# Newmar Corporation

TSB 547 Aug. 22, 2019  
Amended September 14, 2021

## TECHNICAL SERVICE BULLETIN

**Problem: Flickering ceiling lights in early-production 2020 coaches**

*Example of -Mod board with orange and black wires.*

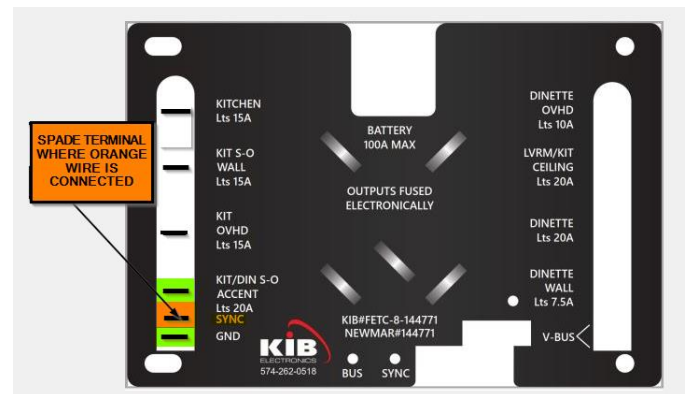
11. Repeat the process for the two remaining circuit boards.
12. Once all three circuit boards are mounted, take the orange wire at the bottom of each new board, and connect them together with a bell cap. Then do the same for the black wires.

Note: The circuit board's parts listed in this bulletin are being phased out. You may receive a newer circuit board that does not have a black and orange wire present. In this case, all the wires will be hooked up the same way; however, it is also necessary to add an orange wire with a spade terminal to the terminal labeled "sync." The sync wire (-mod board) or sync terminal (newer replacement board) provides the ability to connect the three (3) boards together.

If you have a mixture of boards with the orange and black wire and some without the orange and black wire, the orange wire(s) that you added to the sync terminal(s) and the orange wire(s) on the -mod board(s) need to be connected, which will allow the boards to communicate. The black wire on the -mod board is a ground wire. Any of the -mod board(s) with the black wire need to be grounded. The newer version of the board only needs the ground connected to the GND terminal.
